Site Specific
TRAFFIC CONTROL PLAN
For FAIRFIELD BR# 0282(25)

RESUBMIT YES **Rejected**
BY RY DATE 12-24-2014

PROPOSED IMPROVEMENT
BRIDGE PROJECT

PROJECT DESCRIPTION: REPLACEMENT OF EXISTING BRIDGE (BRIDGE NO. 14) WITH RELATED ROADWAY APPROACH AND CHANNEL WORK.

TRAFFIC LAYOUT SHEET

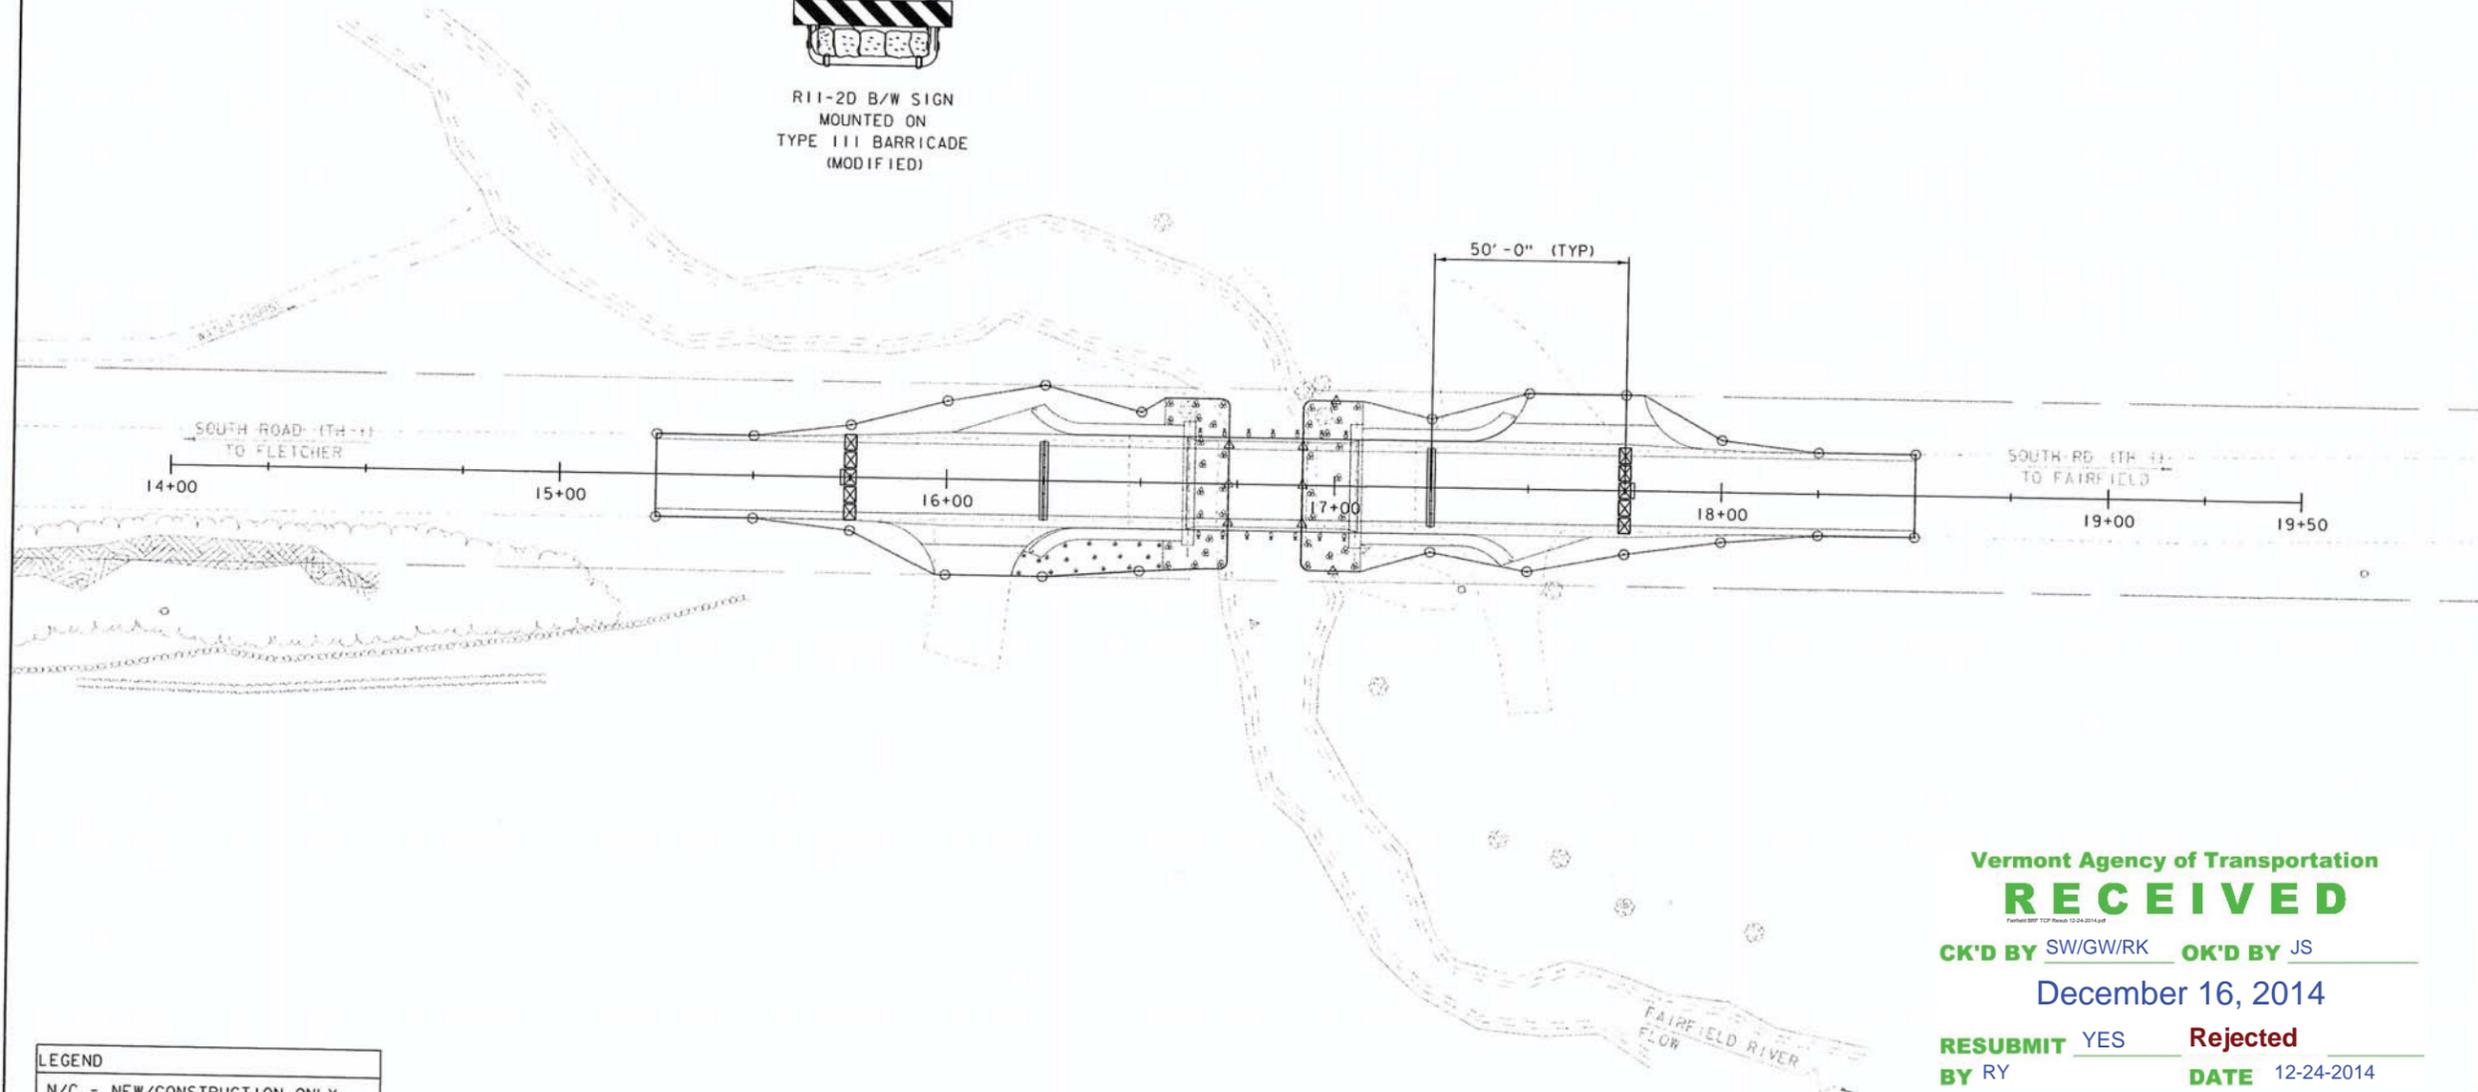
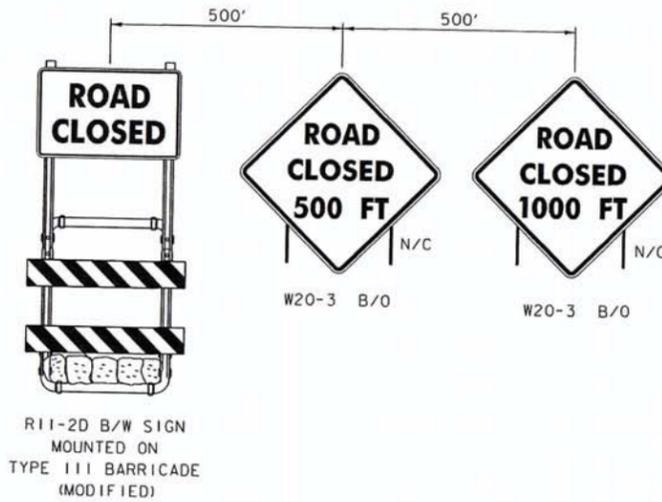
Identify signs, sign locations, and flagger locations. Show distances between bridge, flaggers, and sign locations similar to MUTCD TA-10 (Chapter 6).

Show PCMS locations and message.

TCP3

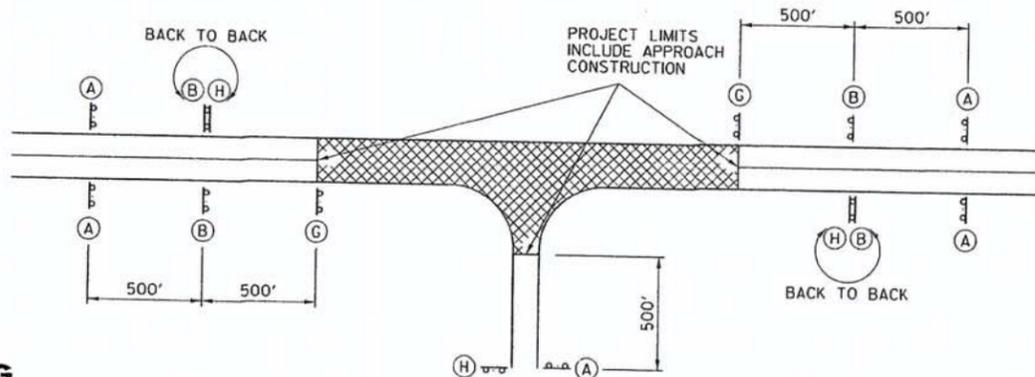
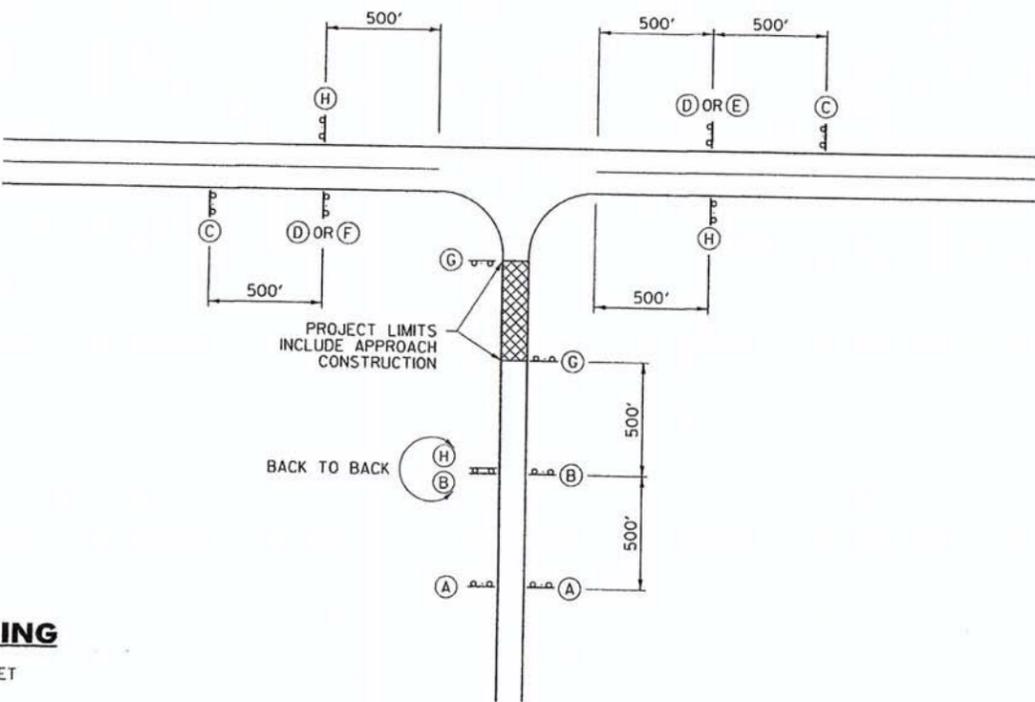
Identify what is being used on this sheet.

TCP 4

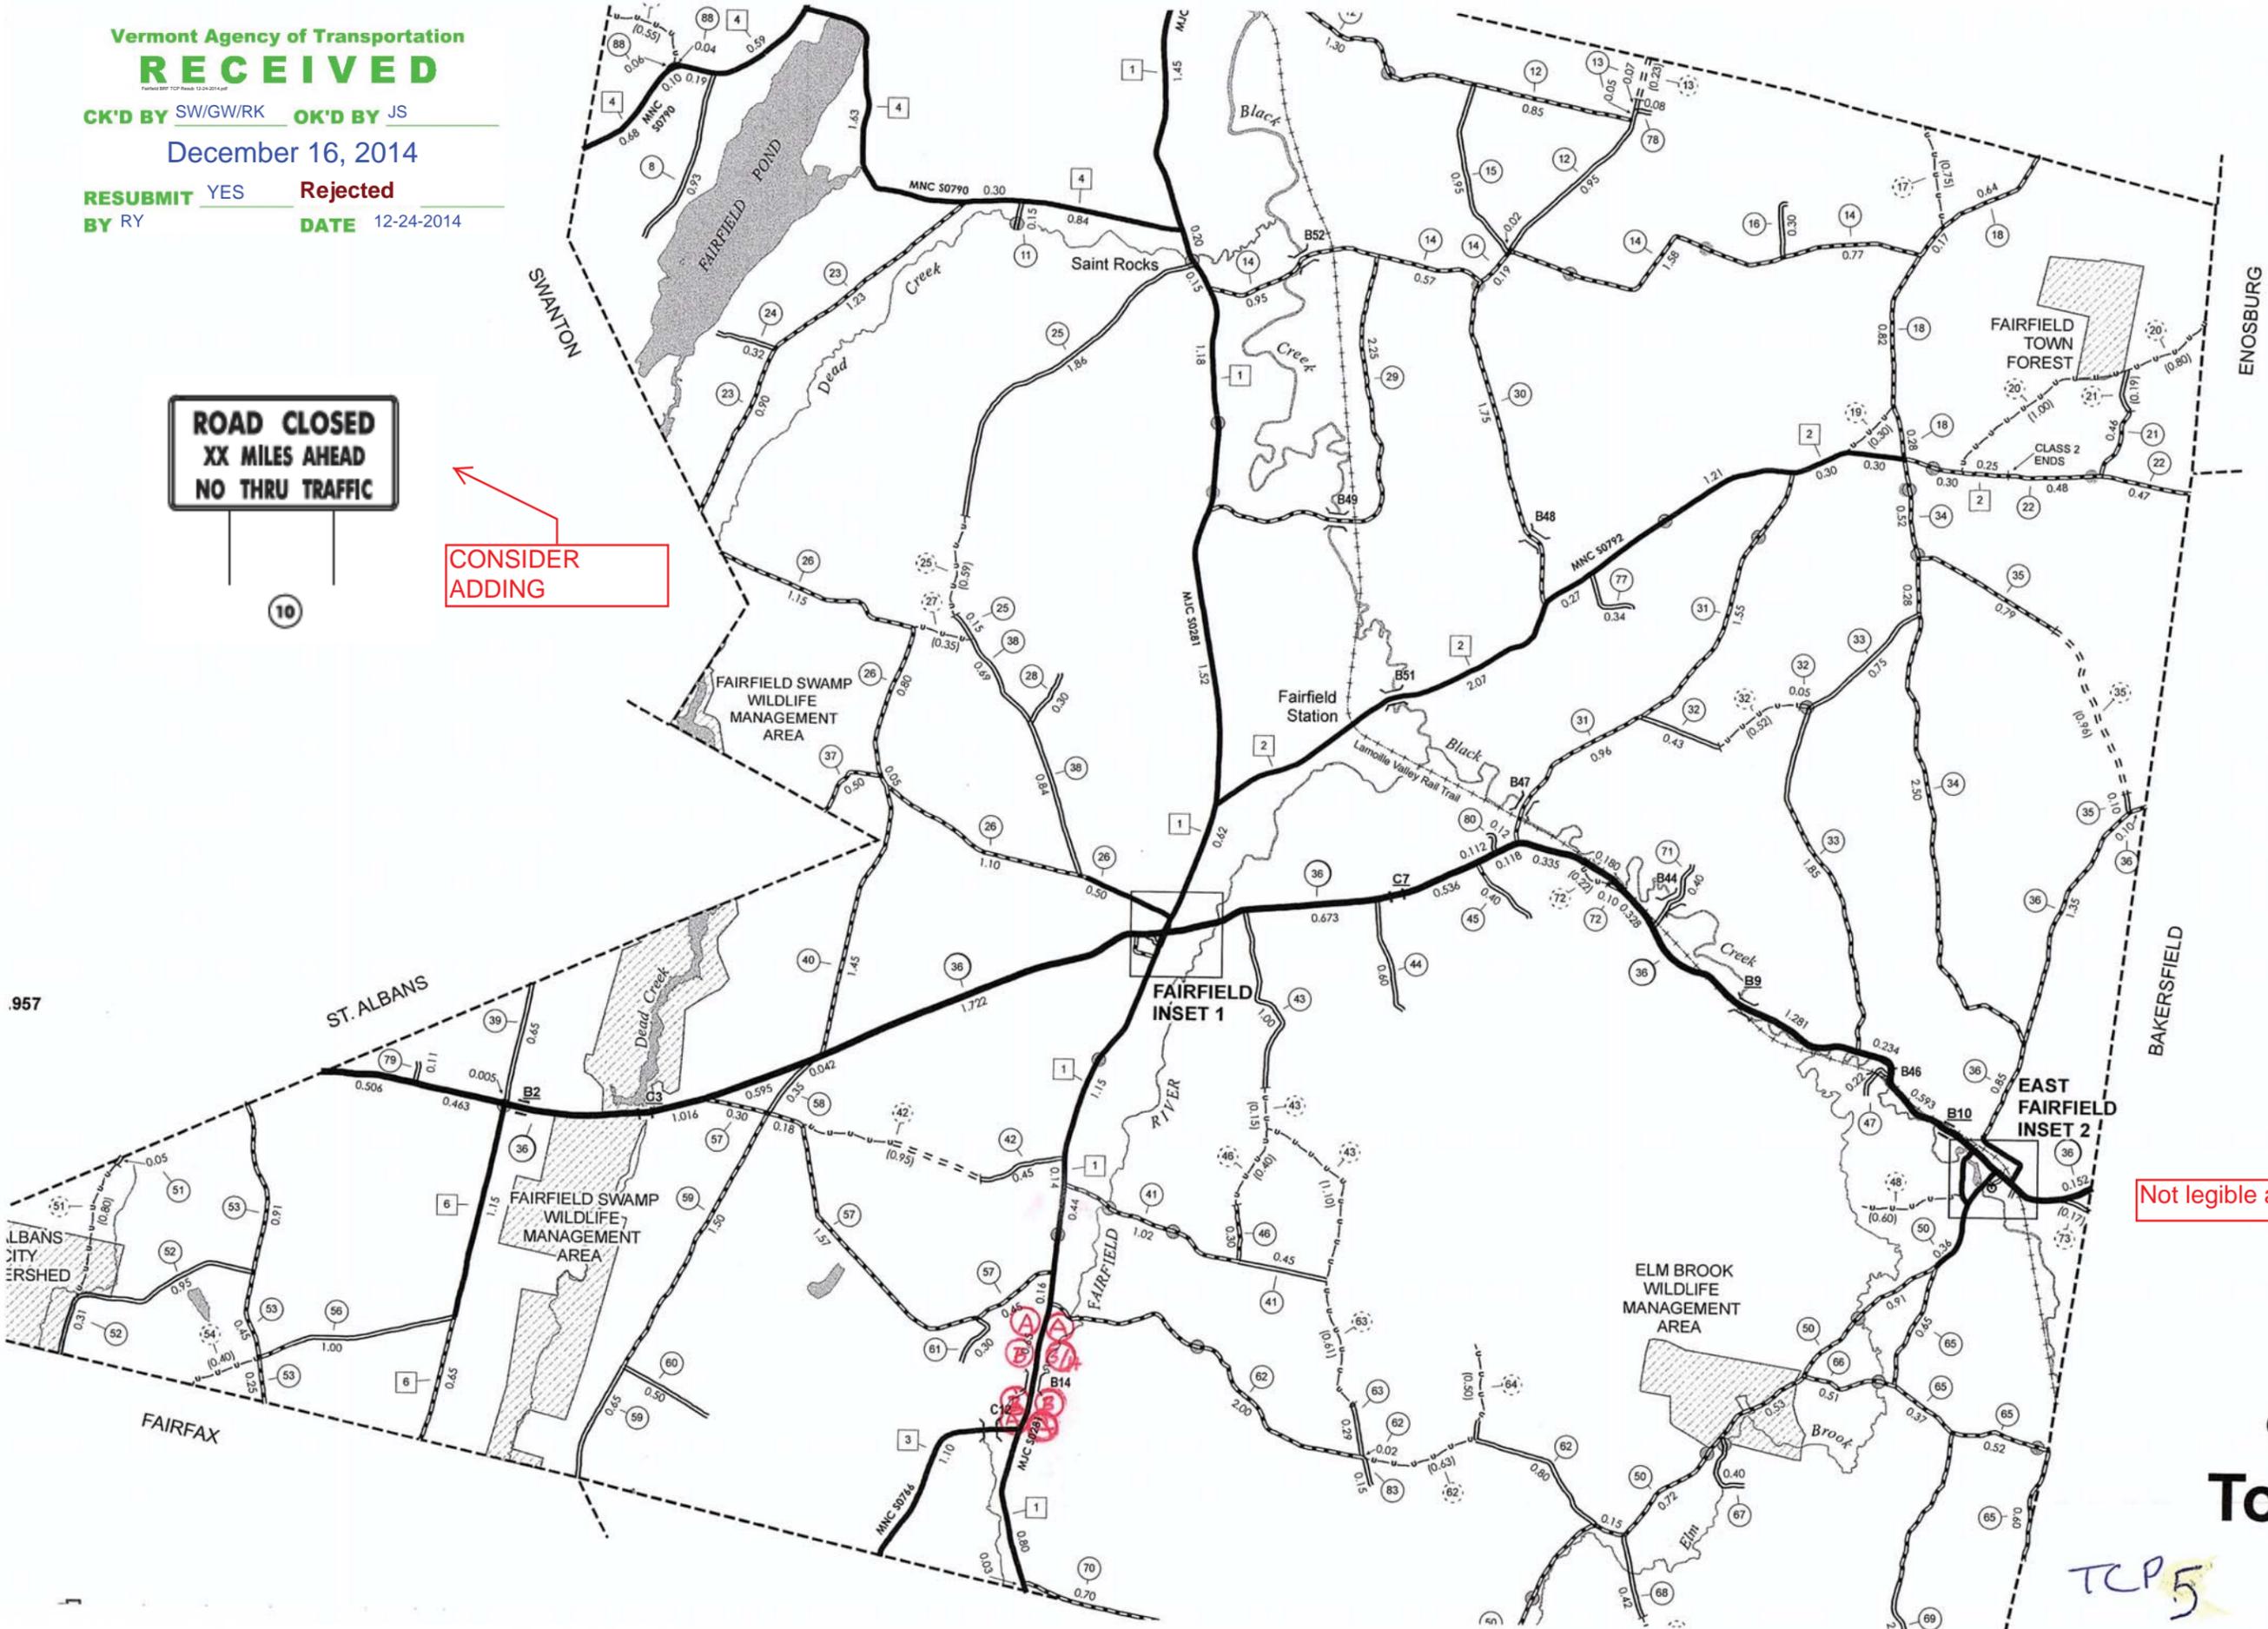
CONSIDER
ADDING

Not legible at this scale.
